# CHANGE ORDER

Construction for  
New Start Center of Everett  
1602 SE Everett Mall Way  
Everett, WA 98208

CO Number: 04  
Date: 4 June 2025

**Prime Contract Potential Change Order #012: PTHP Relocation**

4A  
A4.1  
OVERALL EXTERIOR ELEVATION - NORTH  
SCALE: 1/16" = 1'-0"

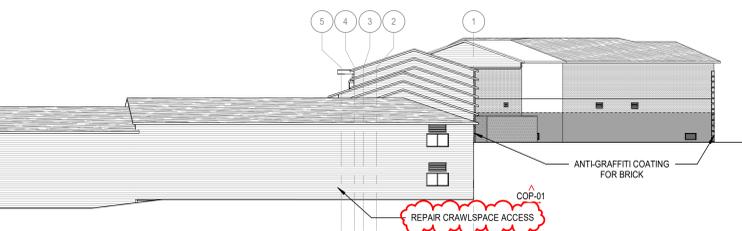
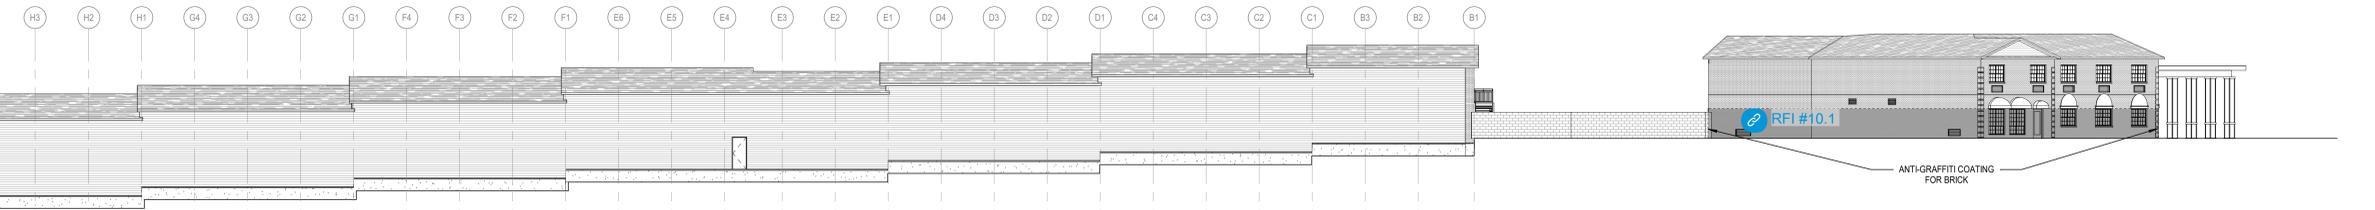
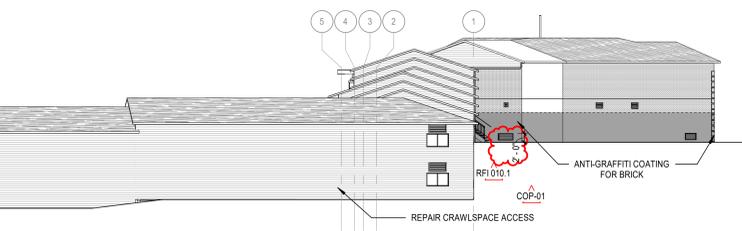
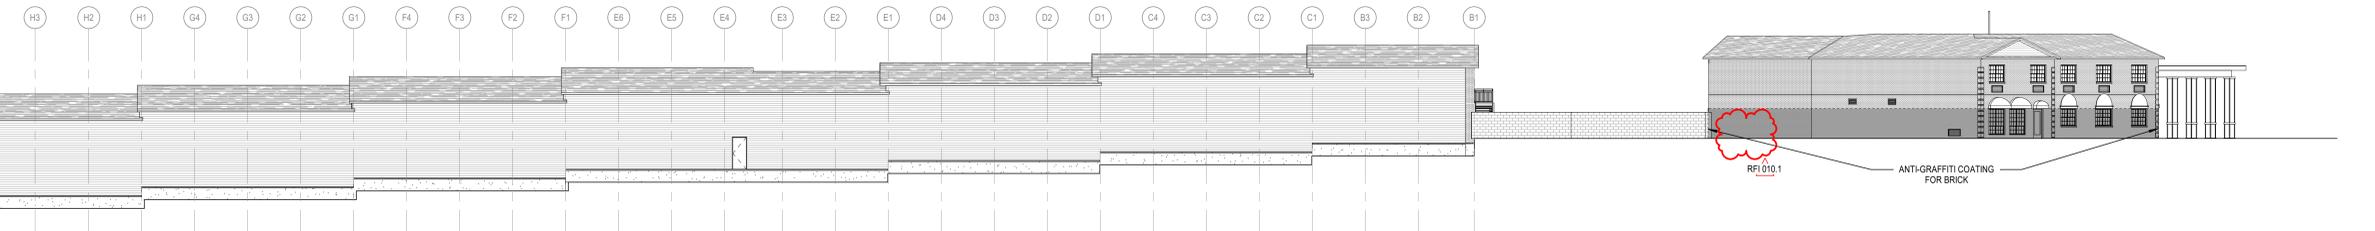
MEP drawings call out PTHP - 1 at unit 108(Wellness room), Building elevations(North elevation) doesn't call out an opening for the unit. Can you please confirm the presence of the unit.

Refer to A1.1A and A4.1 for proposed location for new PTHP-1 unit.

<p><b>Mia Miranda</b> added a response: Please see uploaded PDF response, which includes, but may not be limited to, the following comments: * Install PTHP-1 at room 108 as indicated in the mechanical drawings. A1.1A and A4.1 (attached) have been updated to reflect this new penetration.                      added the <b>response attachment</b> to:  <a href="#">EV_RFI 010 WELLNESS ROOM PHTP - 1 OPENING CONFIRMATION-DLR . RESPONSE.PDF</a></p>	<p><b>Mia Miranda</b></p>	<p>Apr 16, 2025, 12:15 PM PDT</p>
<p><b>Lance Meinhold</b> added a response: There currently is not a unit in the north wall. Further, the north wall is only 3'-7" from the property line. Thus introducing a PTAC unit at this location would also require the installation of a fire damper, which is not possible with a PTAC unit. Locate the PTAC unit in the east wall of the room. This will need to be a new unit and a new opening.</p>	<p><b>Lance Meinhold</b></p>	<p>Apr 15, 2025, 10:40 AM PDT</p>

**BUILDING A - LEVEL 01 FLOOR PLAN**  
SCALE: 1/8" = 1'-0"

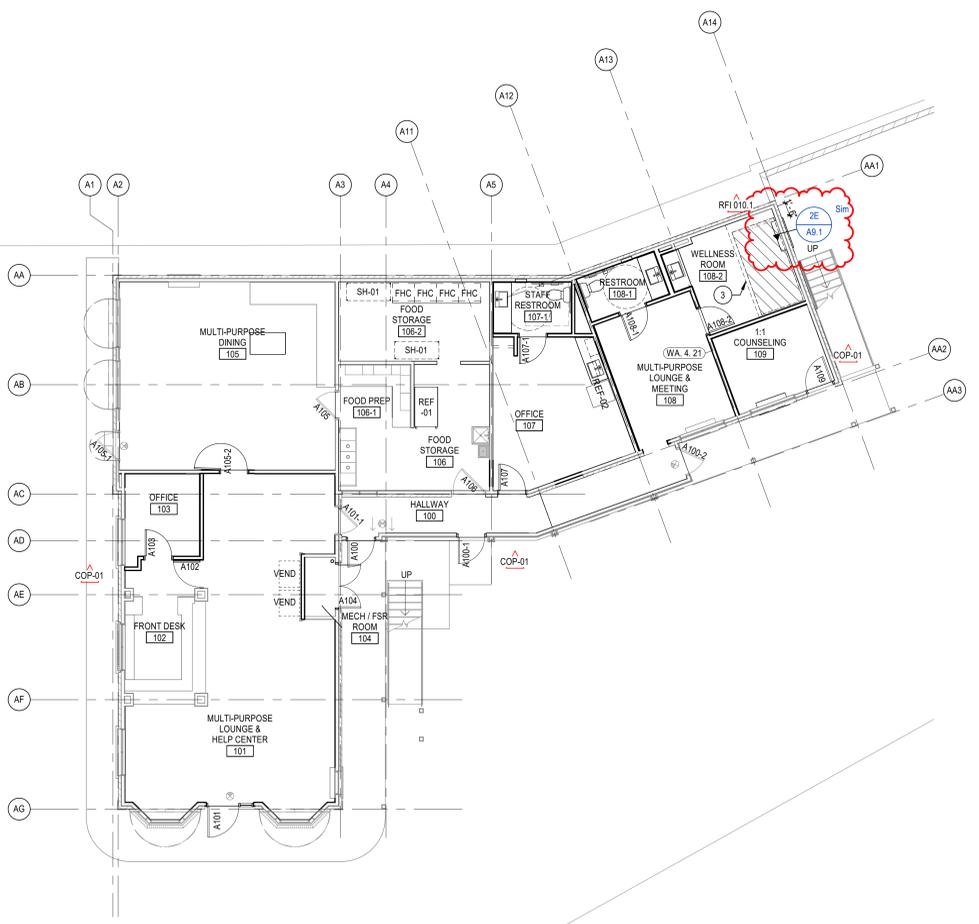
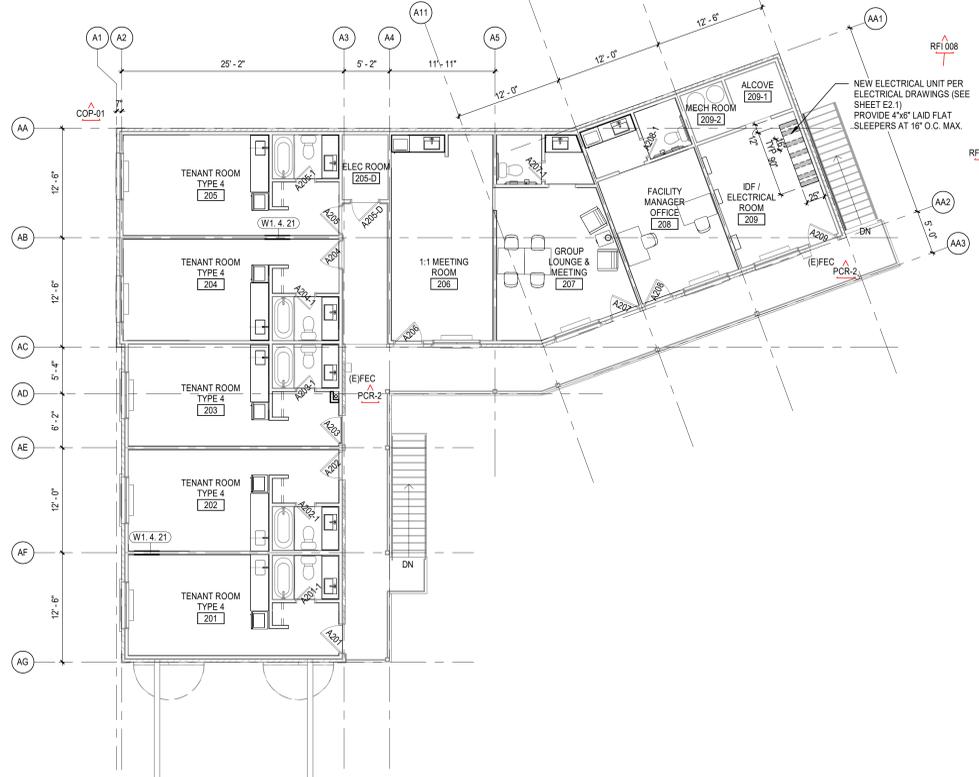
Cost incurred to extend electric circuits to the wellness room PTHP from the north wall to the east wall.
